## ADDENDUM NO. 2

**DATE:** October 8, 2019  
10/08/19

**PROJECT NO:** 190121

**RE:** AE Gage Center – Building A  
ADD-2, REV #2

SHEET NUMBER	A-304
--------------	-------

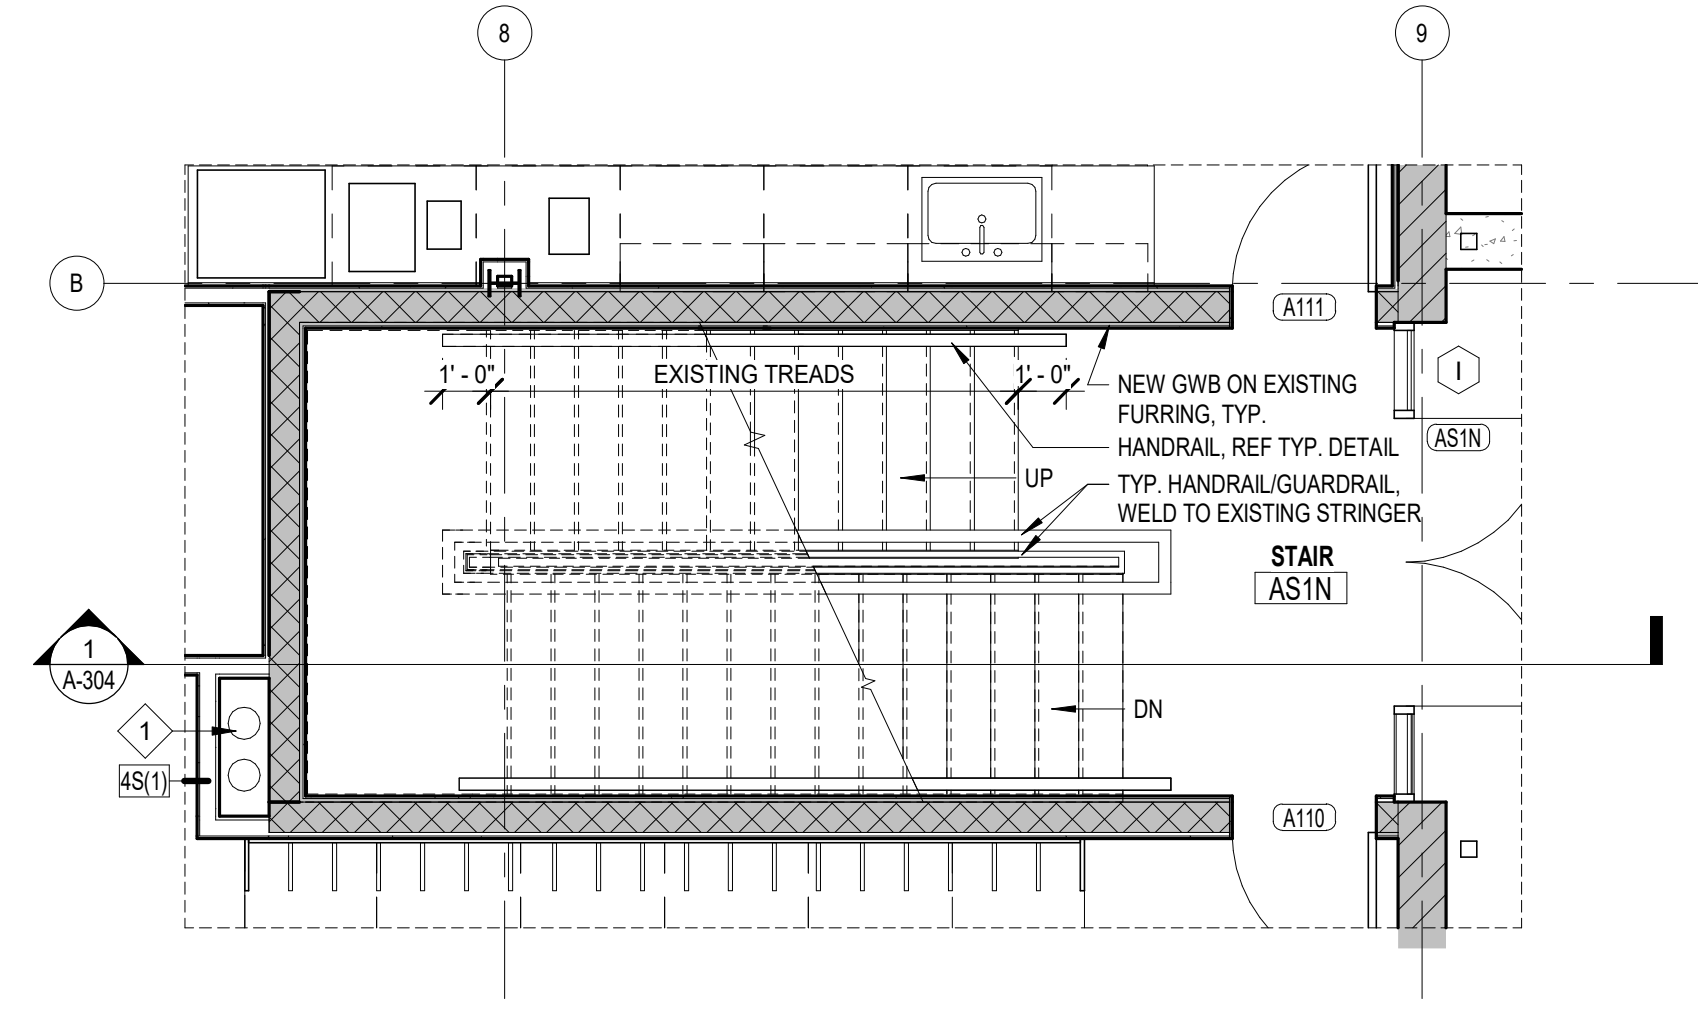
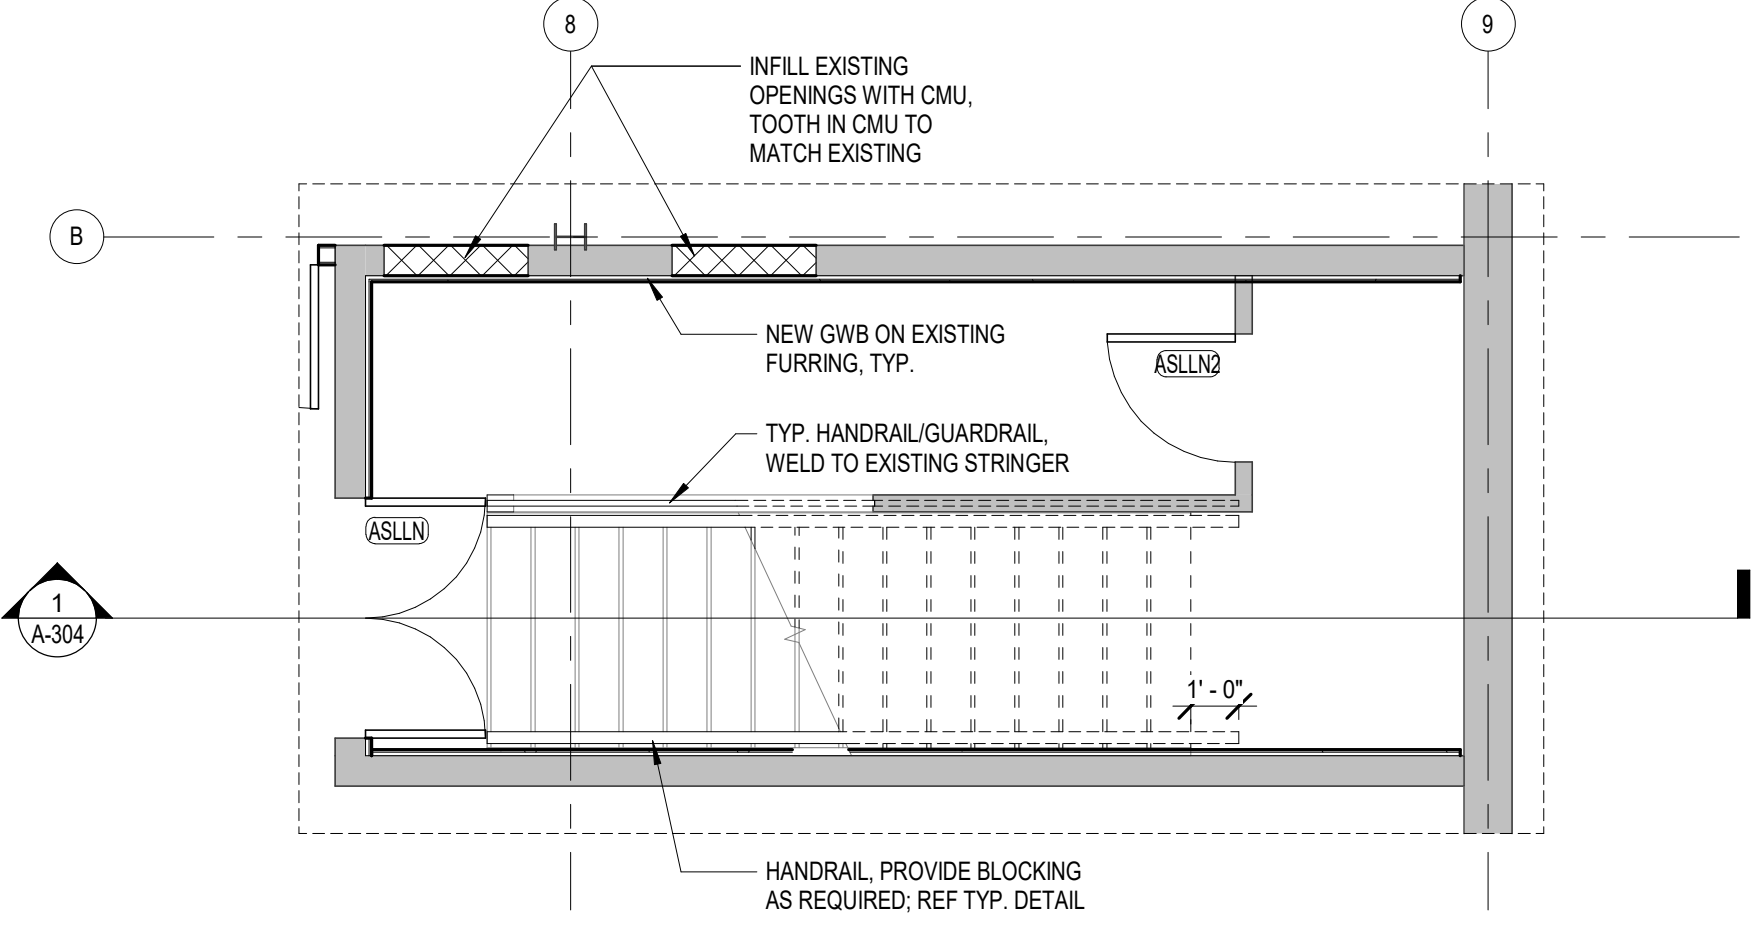
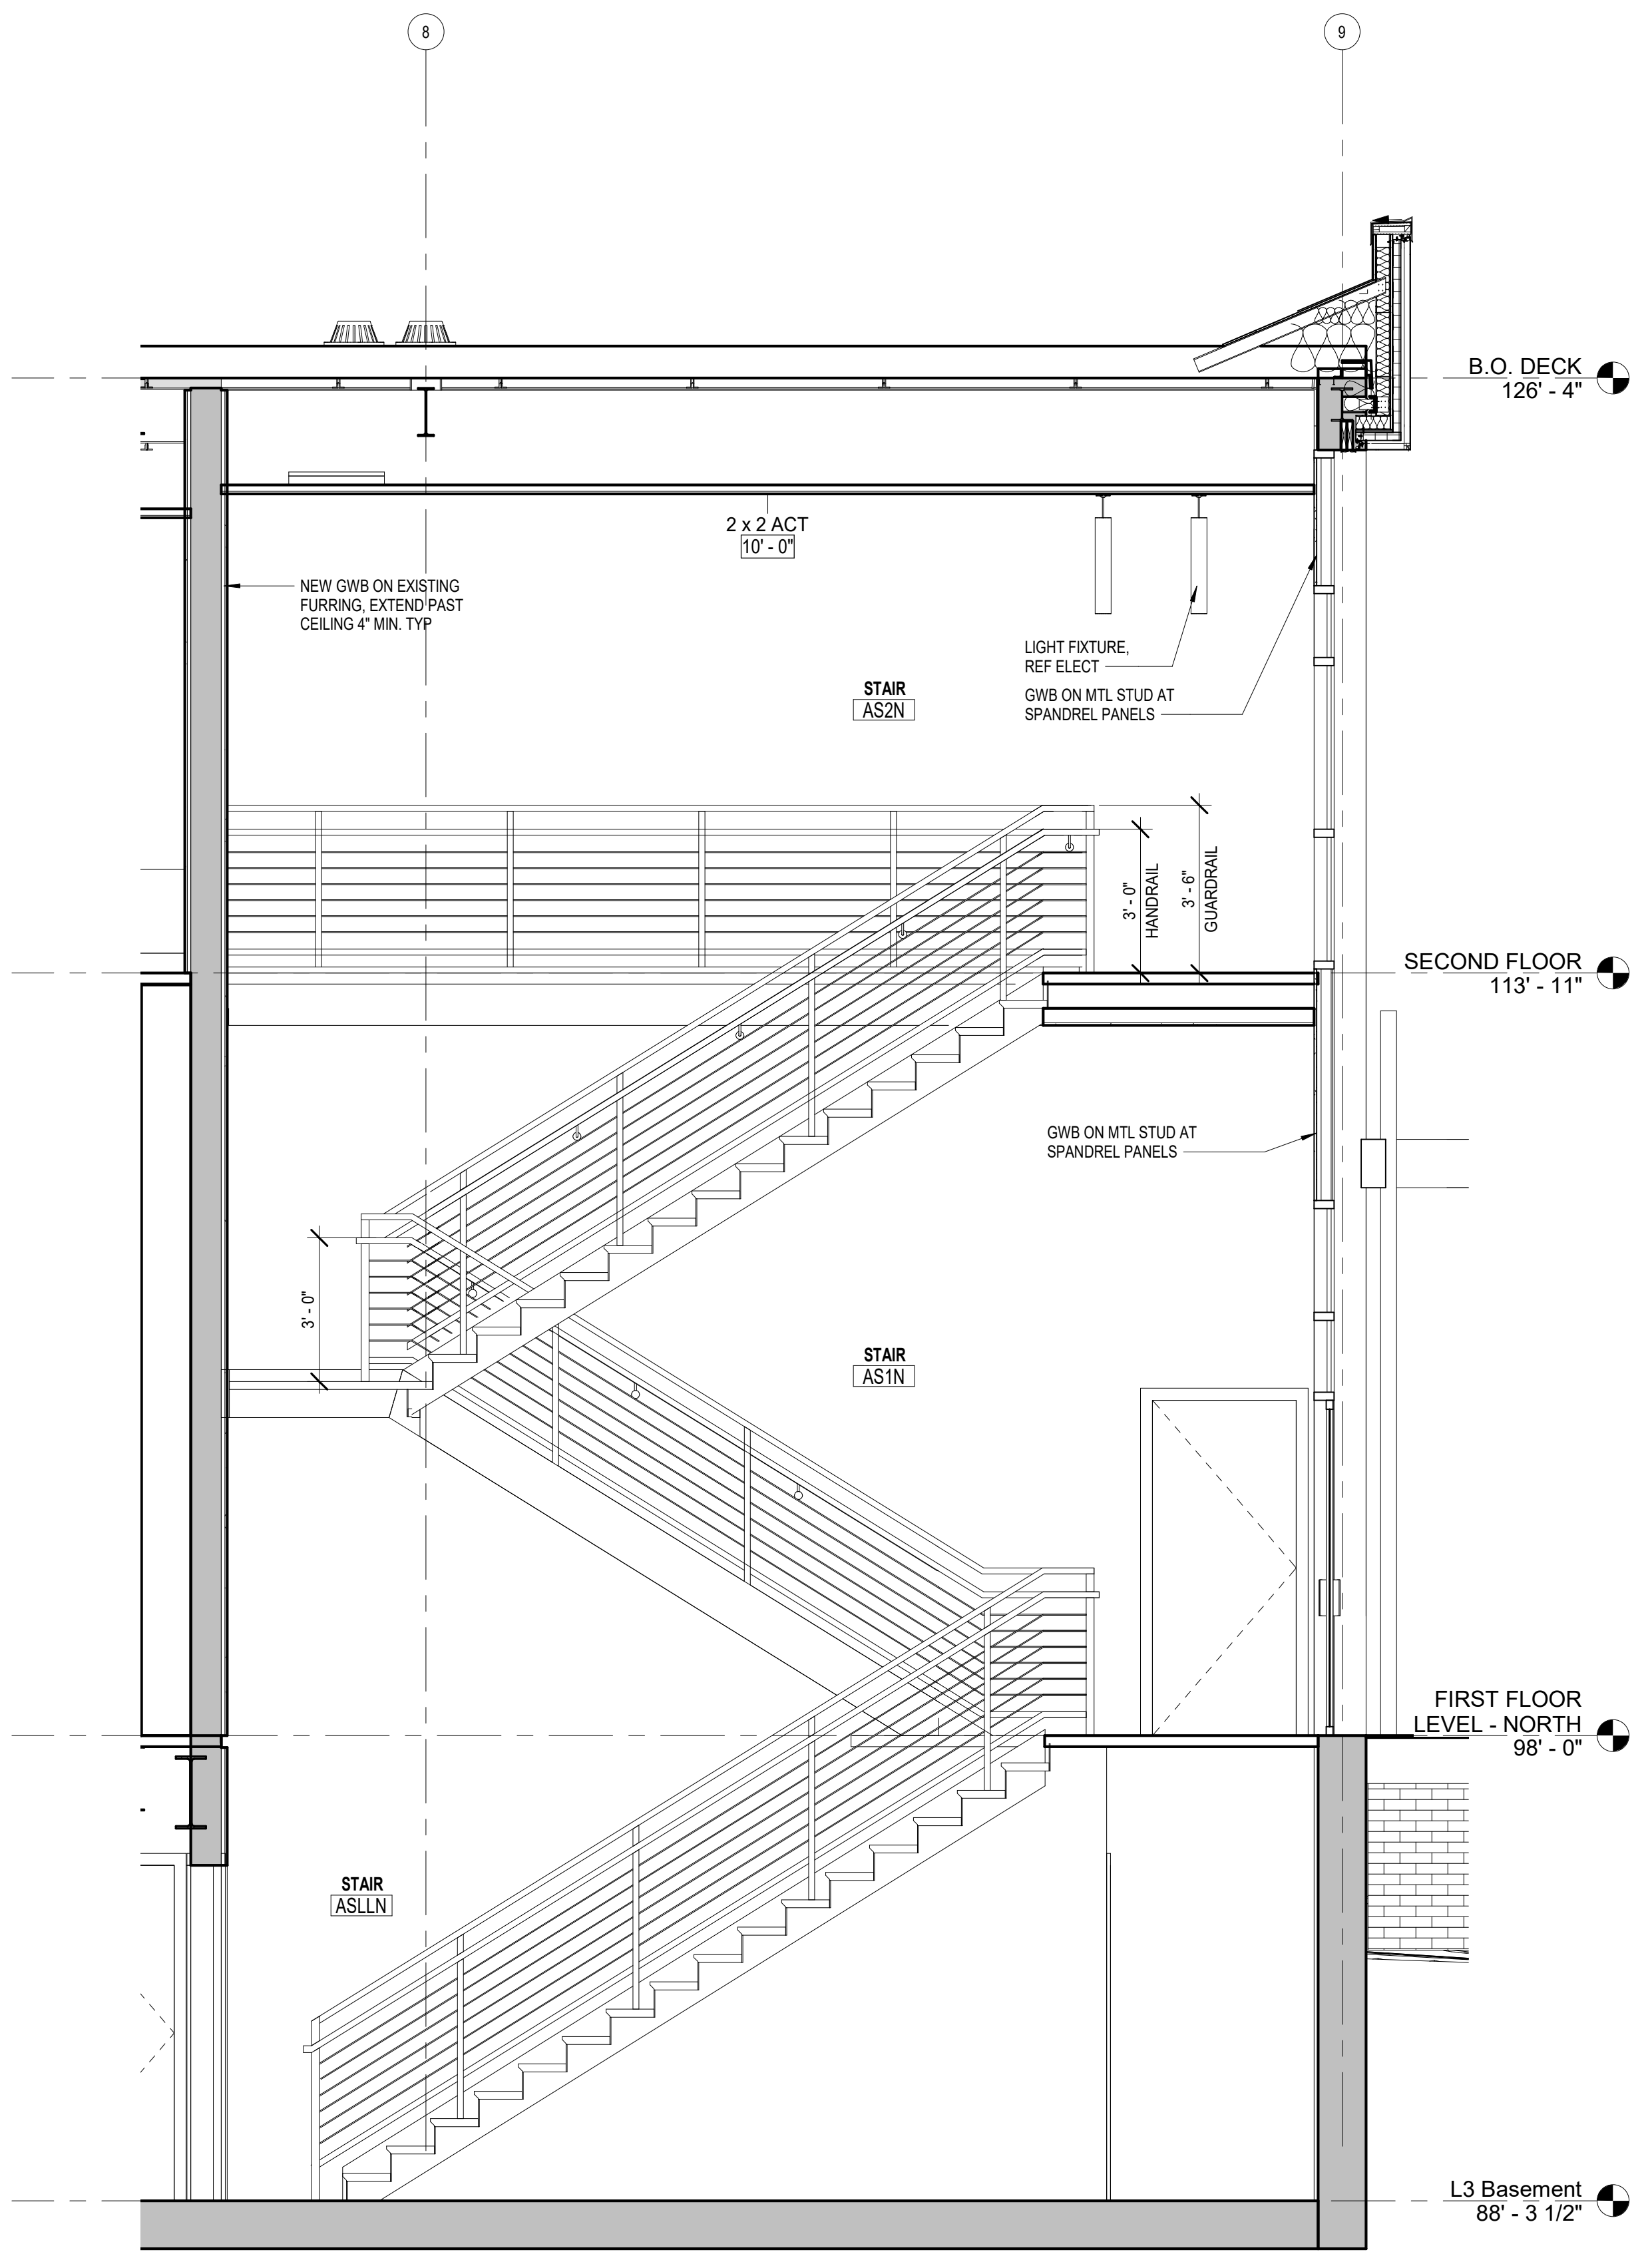
- A-1.D Add section mark 1/A304 and callout 2/A-304 at North Stair.
  - A-1.E The South stair shall be marked as similar to the North stair. The South stair will need a similar handrail and/or guardrail as the North stair. The GWB finish is not required, paint existing CMU.

- A-7.B Stone coping shall be 2’- 1 ¼”
  - A-7.C Provide thru wall flashing at base of wall, term at term bar; typ.
- A-8 ADD Sheet A-304 – ENLARGED STAIR PLAN AND SECTION.

**9 WALL TO LOW ROOF TRANSITION**  
 SCALE: 1 1/2" = 1'-0"

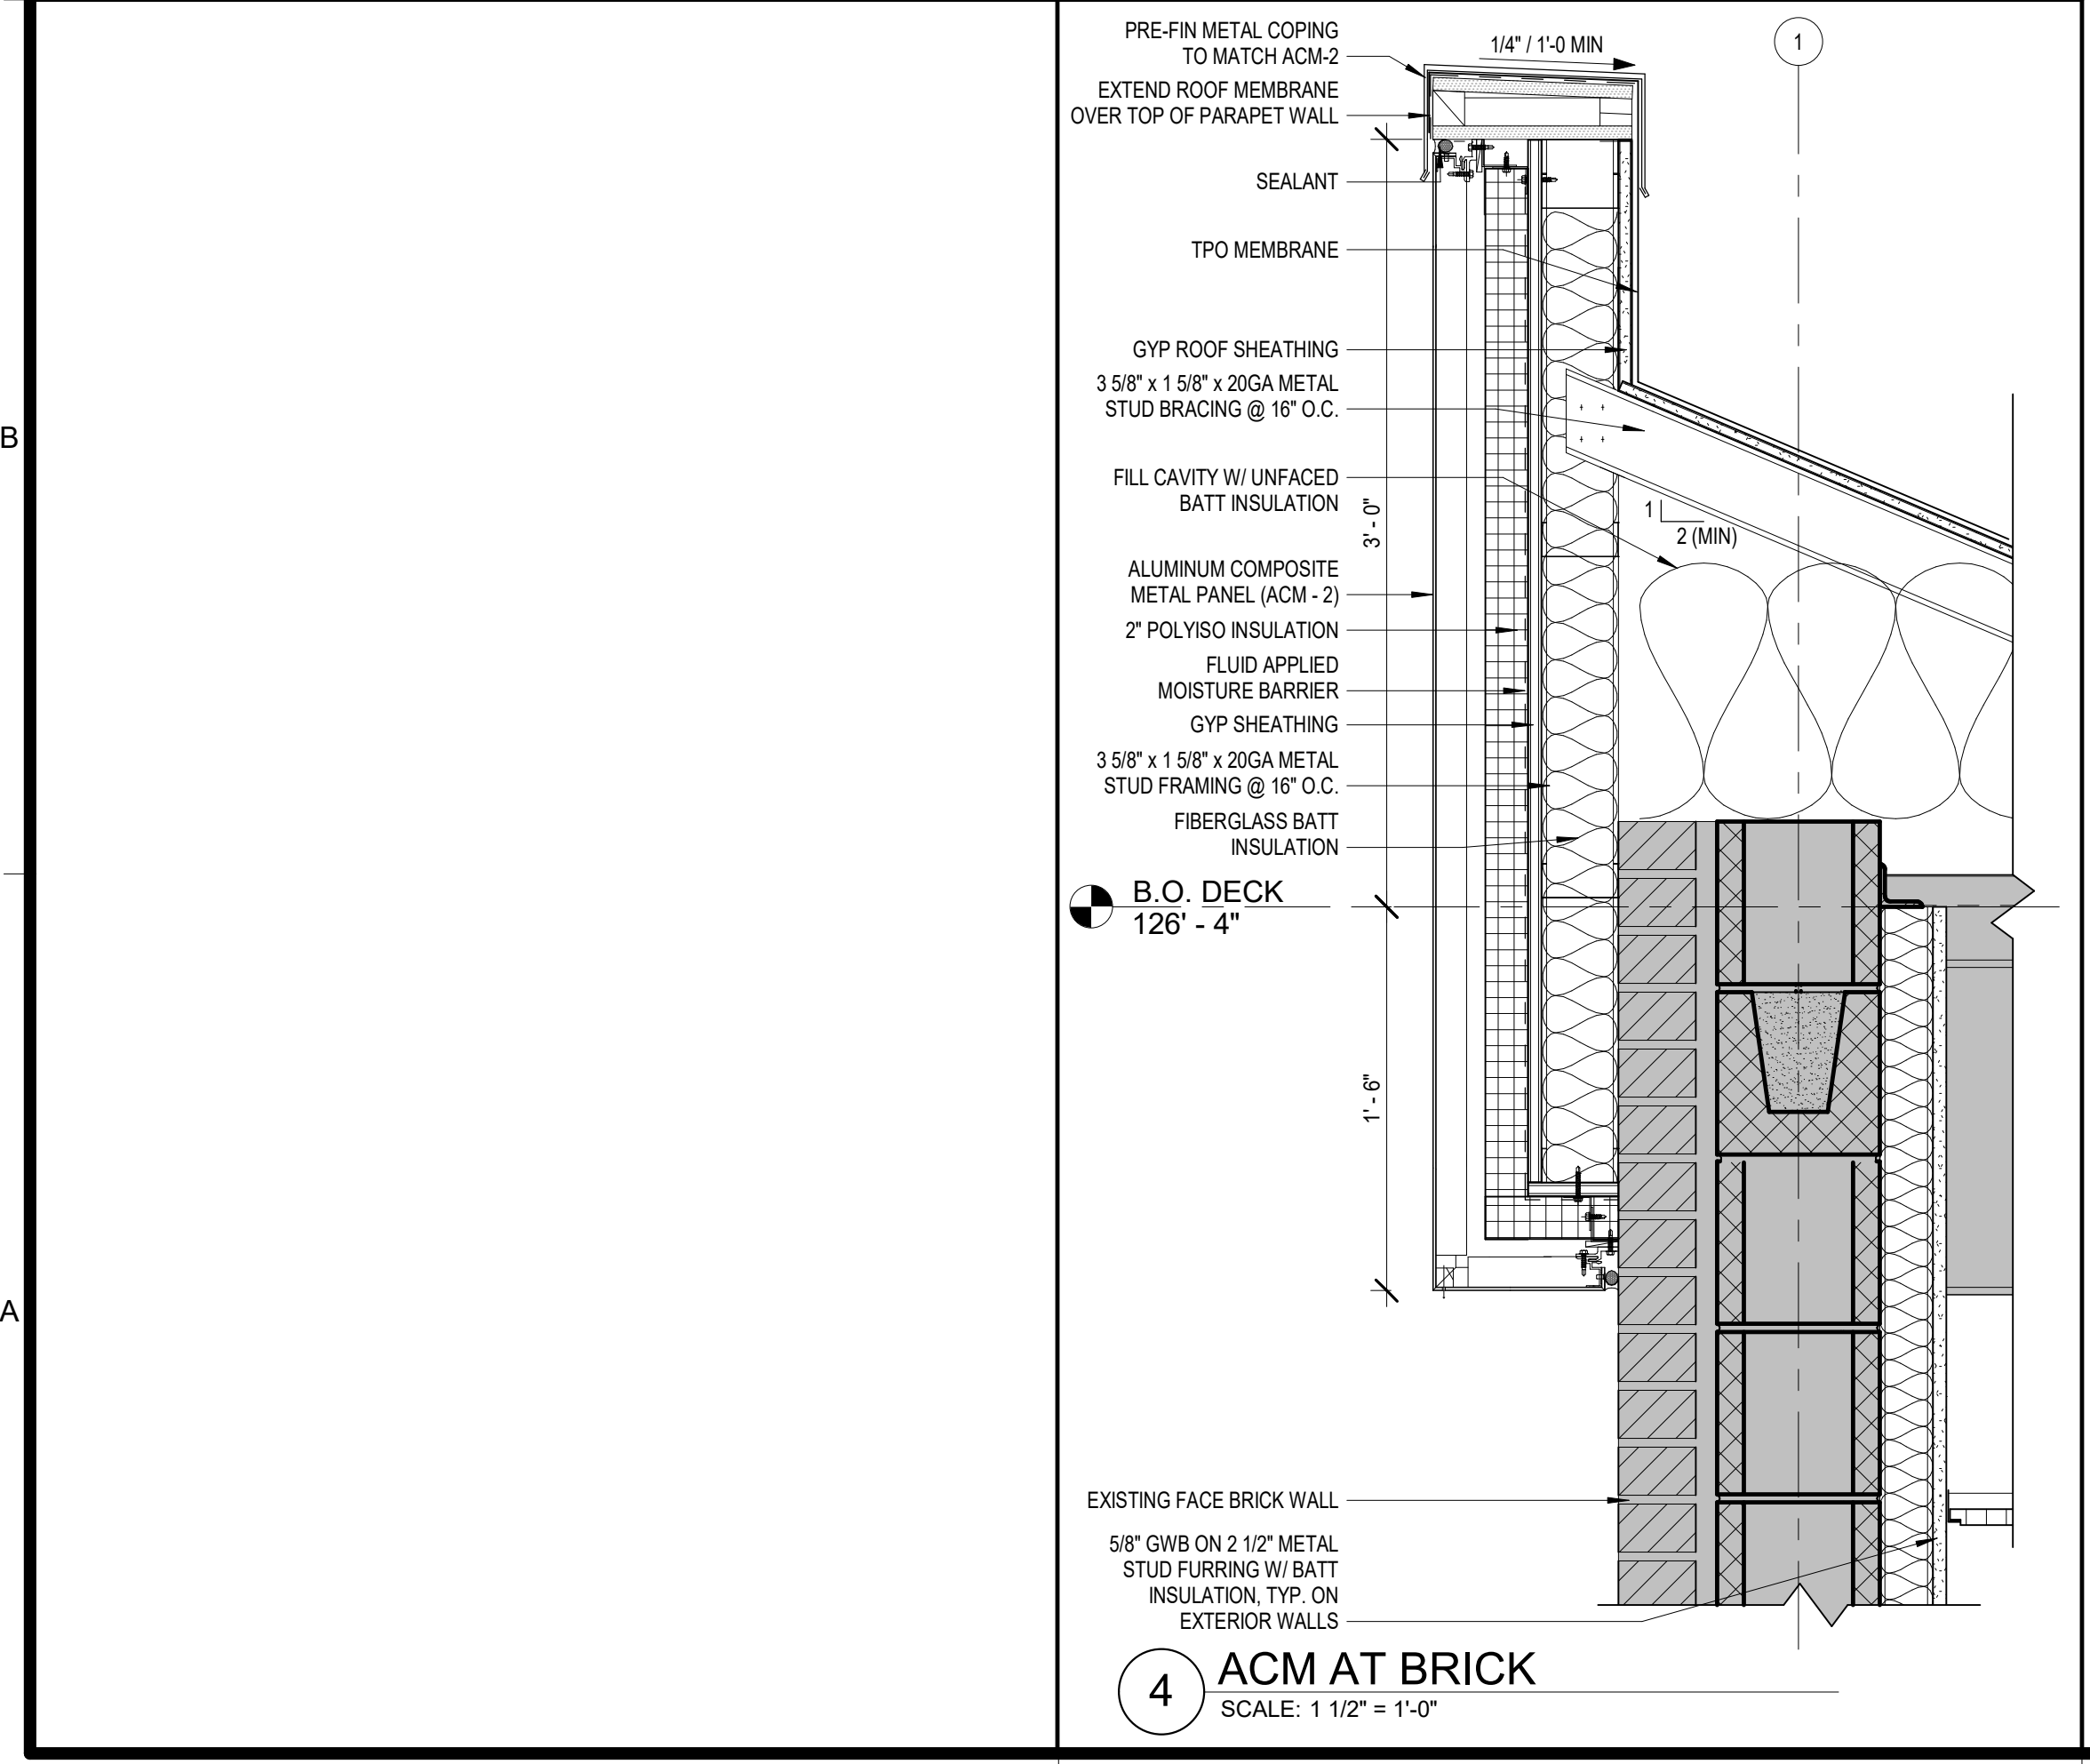
- A-9 Sheet A-501 – BUILDING A – DETAILS – ADD detail 9/A-501 Wall to Low Roof Transition
- A-10 Specification Section 102800-3 TOILET, BATH AND LAUNDRY ACCESSORIES: 2.3 Public-Use Washroom Accessories:
